Reliability Analysis Update

Transmission Expansion Advisory Committee

October 6, 2026

Scope / Cost Changes Dominion

Dominion Transmission Zone: Baseline 500kV Line #588 Rebuild (End of Life Criteria)

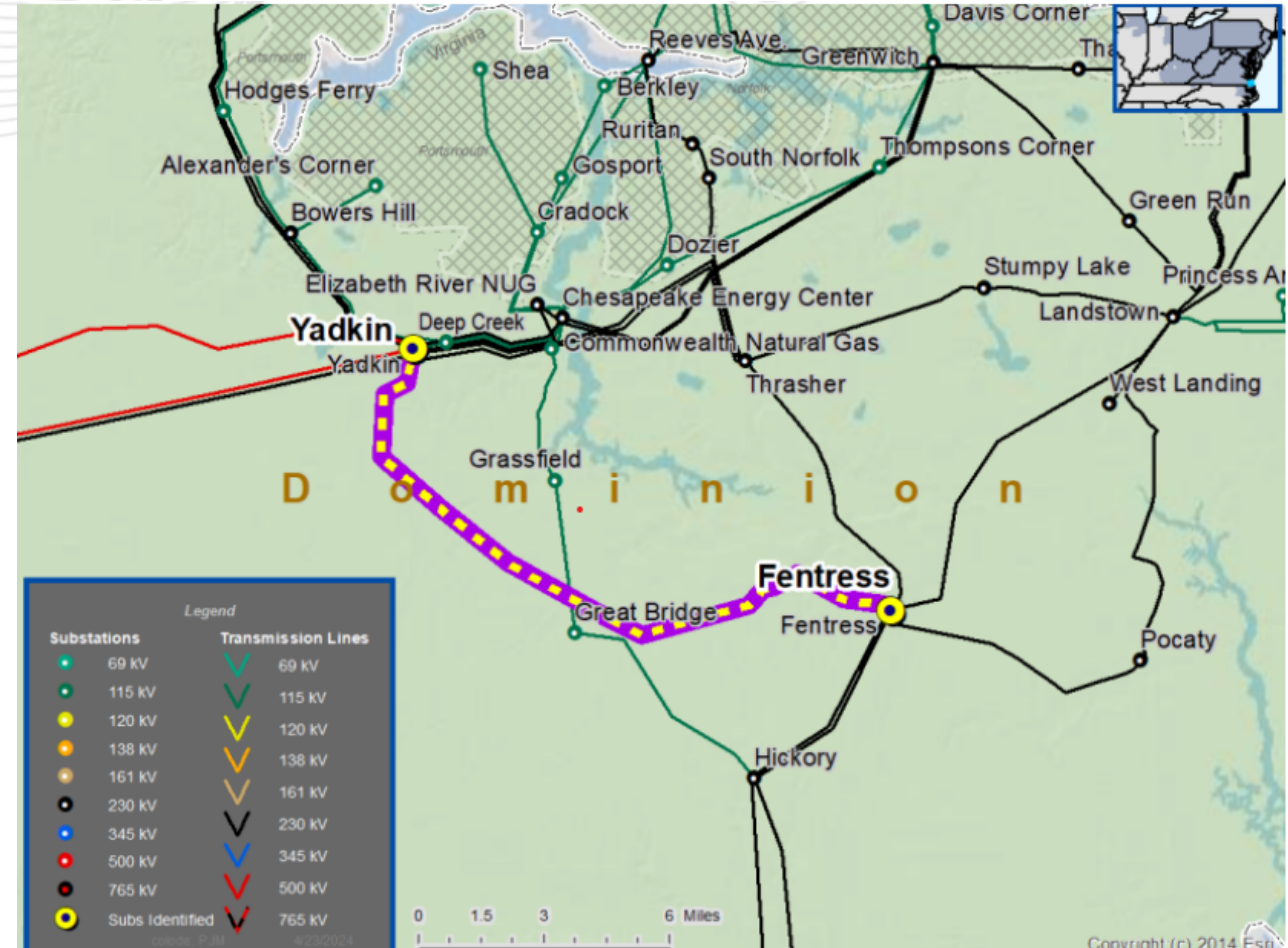
Cost Change for b3850.1 – b3850.3 (2023-W2-367) 500kV Line #588 Yadkin – Fentress Rebuild:

- Rebuild approximately 13.51 miles of 500 kV line #588 from structure 588/184 inside Yadkin substation to structure 588/254 outside of Fentress substation. **(b3850.1)**
- Line #588 terminal equipment at Yadkin substation will be upgraded to a rating of 5000A. Since the new 500kV line will be using fiber, the wave trap will be removed and the line protection scheme will be updated. **(b3850.2)**
- At Fentress substation, since the new 500kV line will be using fiber, the wave trap will be removed and the line protection scheme will be updated. **(b3850.3)**

Transmission Estimated Cost: ~~\$79.7M~~ \$113.8M

Reason for Project Update:

- Construction bids for the transmission line work were received above the original estimate.
- Permitting delays resulted in schedule impacts, leading to change orders for both standby time and schedule acceleration.
- Material delivery delays affected project execution and required additional change orders to recover schedule and maintain project milestones.

Dominion Transmission Zone: Baseline 502 Jct-Woodside-Aspen 500 kV & Doubs Corridor Projects (DOM Portion)

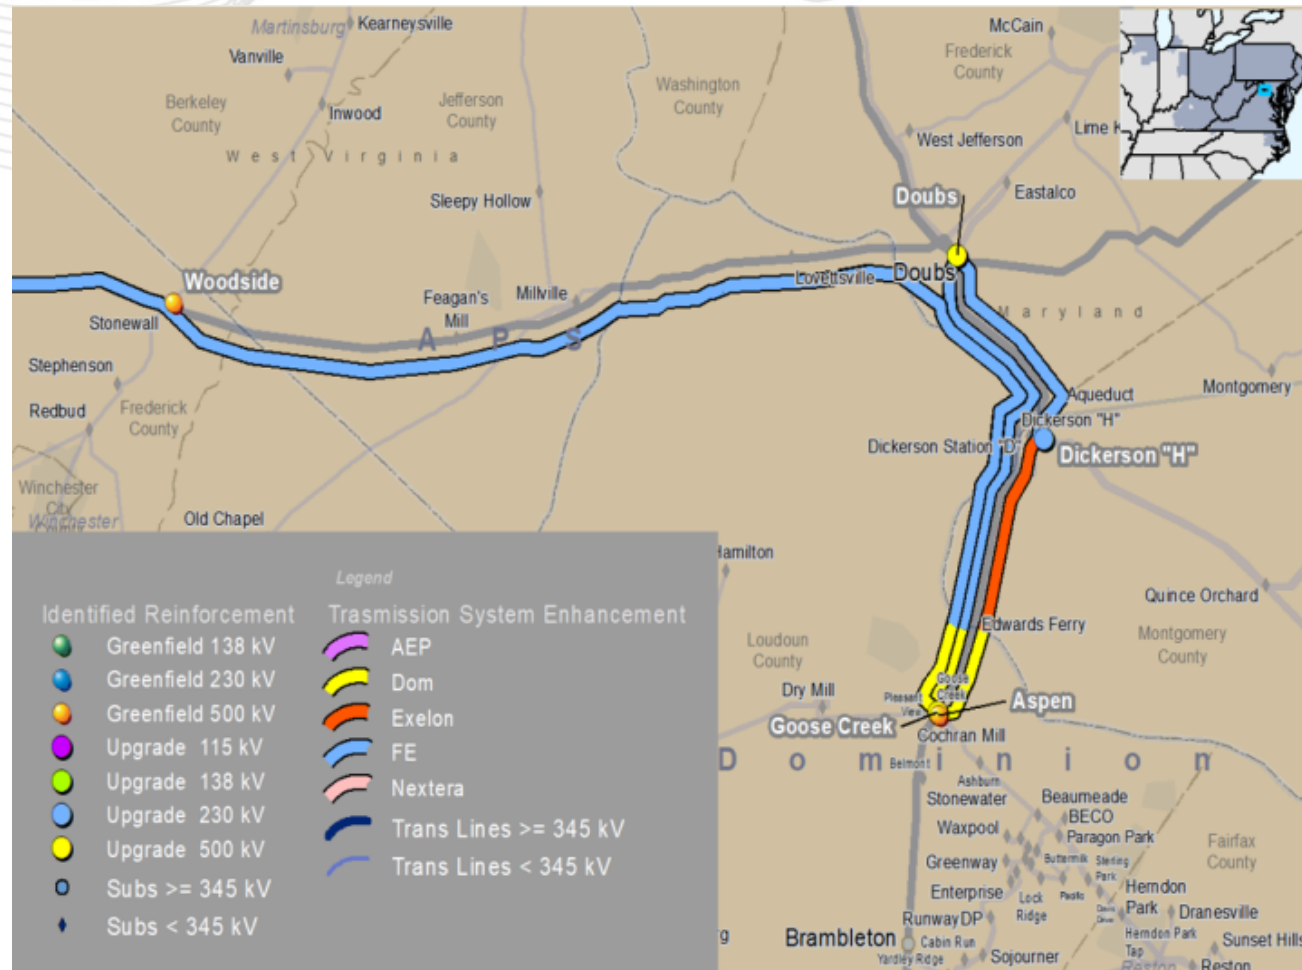
Cost Change for b3800.118, b3800.120 & b3800.375 (2022-W3-853) :

- Line work for terminating Doubs to Bismark line into Woodside 500 kV substation. **(b3800.118) - \$5.1M**
- Terminate new NextEra 500 kV line from Woodside into Goose Creek substation. The Goose Creek 500kV cap bank will be moved to Aspen substation. **(b3800.120) - \$30.49M**
- Construct new Woodside – Goose Creek 500 kV line for ~3 miles on single circuit monopole structures within the Doubs – Goose Creek Corridor. **(b3800.375) - \$15.60M \$38.35M**

Transmission Estimated Cost: ~~\$51.19M~~ \$73.94M

Reason for Project Update:

- Project costs update are driven by upgraded conductor design, catwalk installation, updated geotechnical conditions, additional splice boxes, increased crossing requirements, taller structures for EMF and clearance compliance, and the inclusion of forestry and access work not accounted for in the previous project.

Dominion Transmission Zone: Thornburg 500/230kV Substation (Line #568 Ladysmith – Possum Point Cut-In)

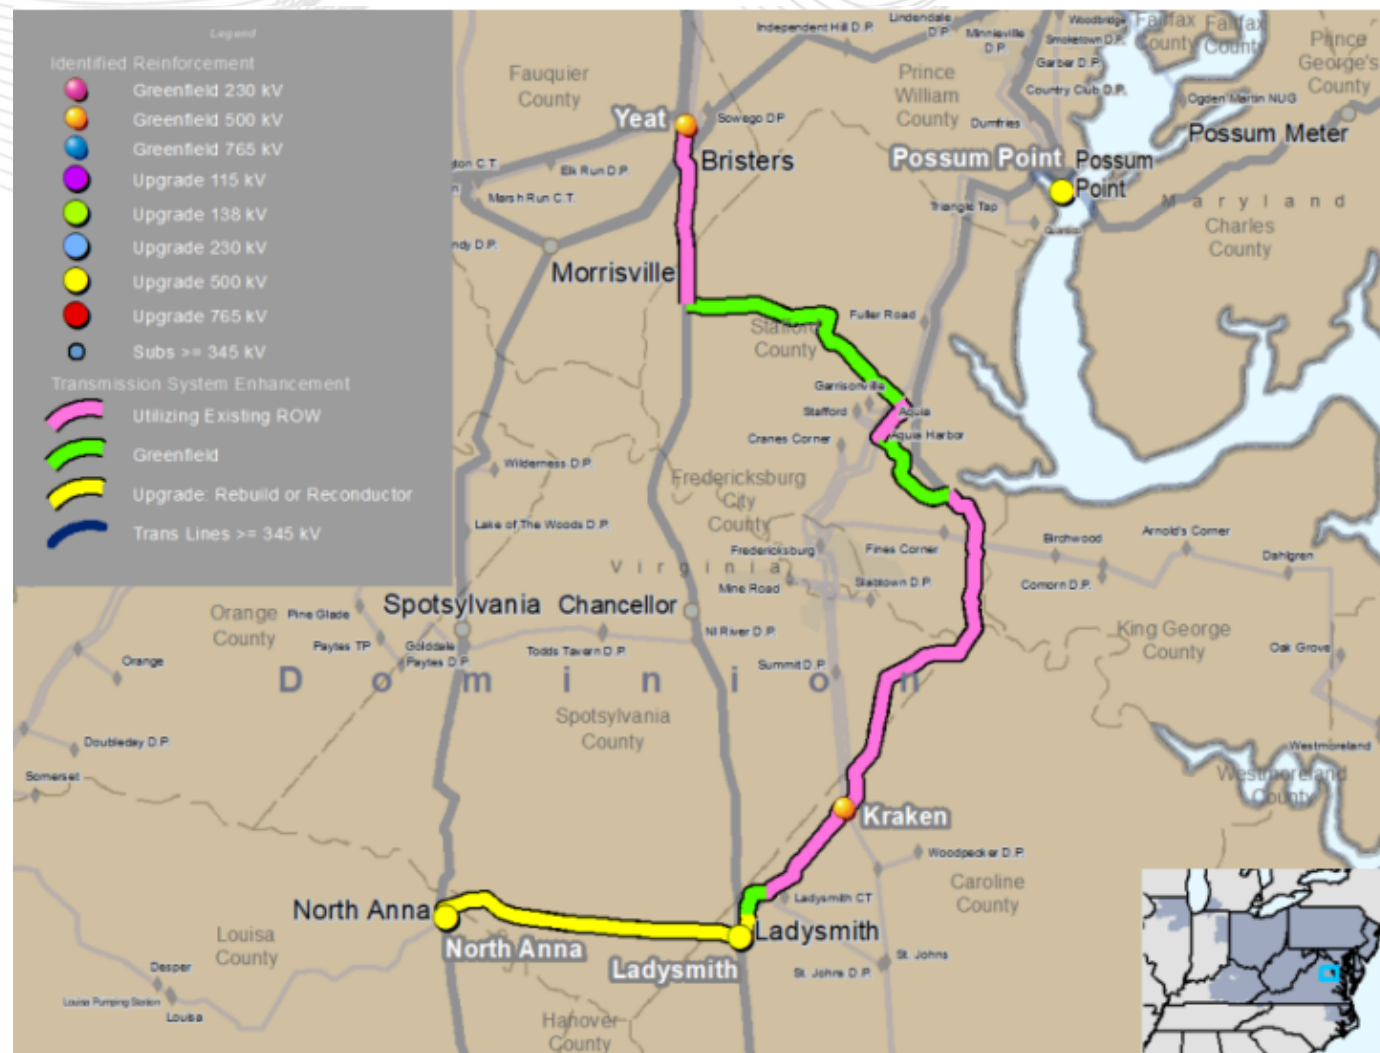
Change in Description & Cost for Original Baseline IDs:

- Cut into line 568 Ladysmith to Possum Point and run to the line of demarcation at Thornburg substation (Ladysmith - Thornburg portion). **Estimated Cost: \$1.1M (b4000.351)**
- Cut into line 568 Ladysmith to Possum Point and run to the line of demarcation at Thornburg substation (Possum Point - Thornburg portion). **Estimated Cost: \$1.1M (b4000.352)**

New Baseline Projects:

- Terminate line 568 Ladysmith to Possum Point from the line of demarcation into Thornburg substation (Ladysmith - Thornburg portion). **Estimated Cost: \$2.5M (b4000.364)**
- Terminate line 568 Ladysmith to Possum Point from the line of demarcation into Thornburg substation (Possum Point - Thornburg portion). **Estimated Cost: \$2.5M (b4000.365)**
- The designated entity for both new baseline IDs is **Valley Link Transmission**.

Reason for new Baseline IDs:

- Further discussion between Valley Link Transmission & Dominion determined that the work for the cut-in of 500kV line #568 Ladysmith – Possum Point into Thornburg substation should be split as highlighted above.

Dominion Transmission Zone: Thornburg 500/230kV Substation (Bypass Elmont & Possum Point 500kV)

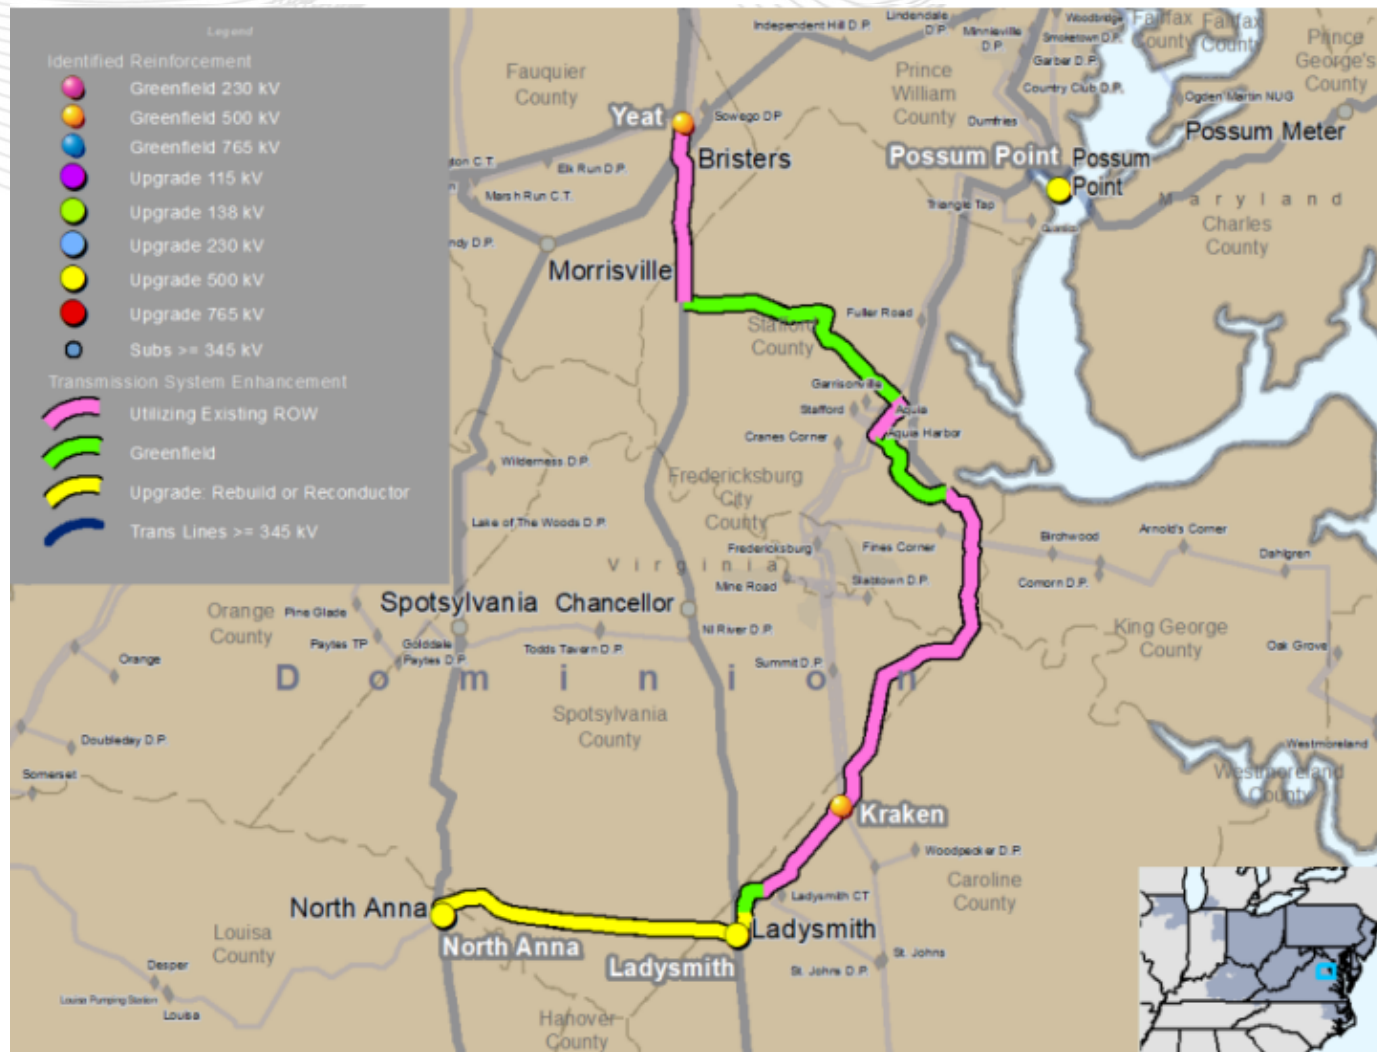
Change in Designated Entity:

- Further discussion between Valley Link Transmission & Dominion determined that the designated entity for this baseline ID should be Valley Link Transmission over Dominion.

Dominion Transmission Zone: Nokesville – ~~Hornbaker~~ Bristow New 230kV Line

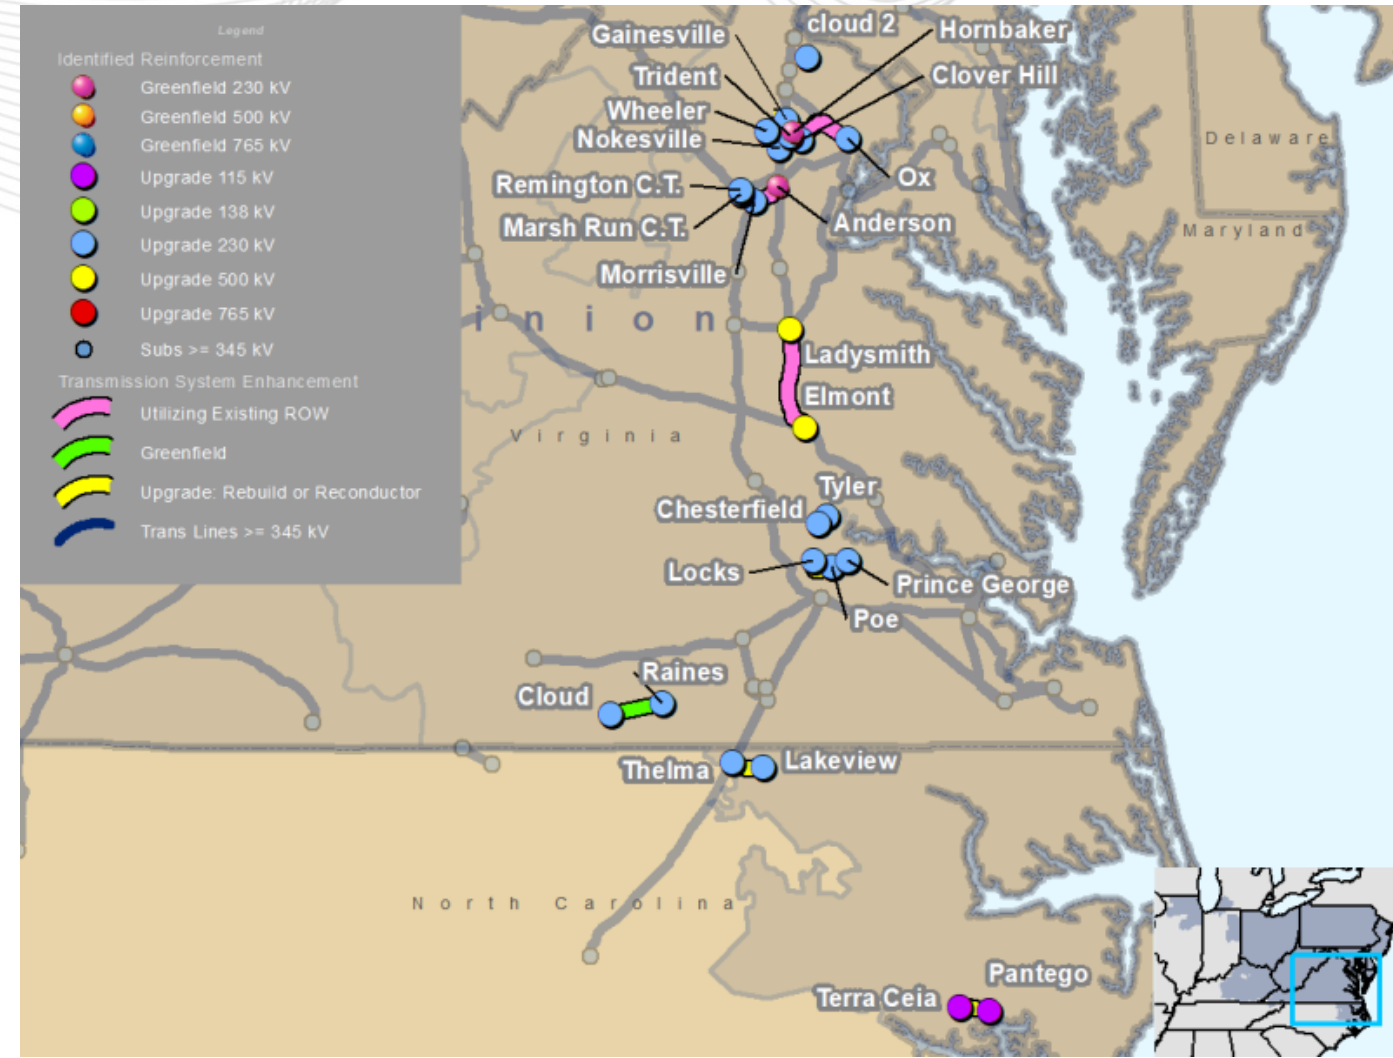
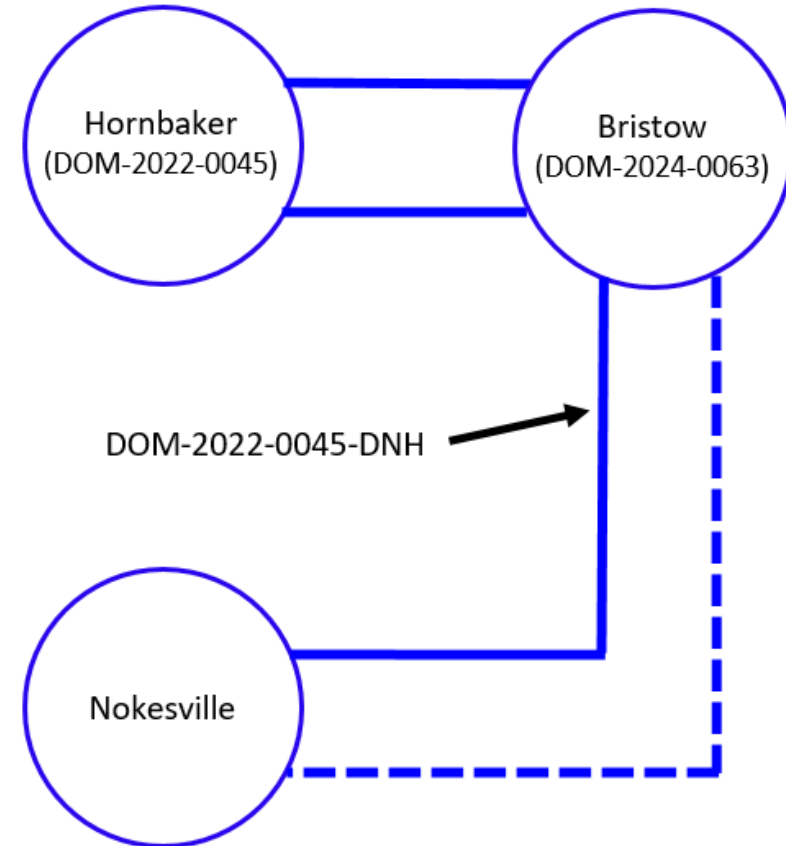
Scope Change for b4000.322 – b4000.324 (230kV Line Nokesville – Hornbaker 230kV line):

Original Solution:

- Build a new 230kV Line from Nokesville – Hornbaker using the vacant arms of the double circuit monopole structures installed as part of a previous project. **Estimated Cost: \$15.28M (b4000.322)**
- Terminal equipment upgrades at Nokesville & Hornbaker. **Estimated Cost: \$2.86M (\$1.43M each) (b4000.323 & b4000.324)**

Reason for Project Update:

- Bristow will be located directly adjacent to Hornbaker. At the 12/03/2024 TEAC meeting, the scope of DOM-2022-0045-DNH (Nokesville-Hornbaker 230 kV Ckt #1) was reconfigured to terminate from Nokesville into Bristow rather than Hornbaker. This change applies the same update to the second 230 kV circuit.

Revised Solution:

- Build a new 230kV Line from Nokesville – Bristow using the vacant arms of the double circuit monopole structures installed as part of previous supplemental project s3035.2. **Estimated Cost: \$15.28M (b4000.322)**
- Terminal equipment upgrades at Nokesville and Bristow 230kV substations. **Estimated Cost: \$2.86M (\$1.43M: b4000.323 & \$1.43M: b4000.324)**
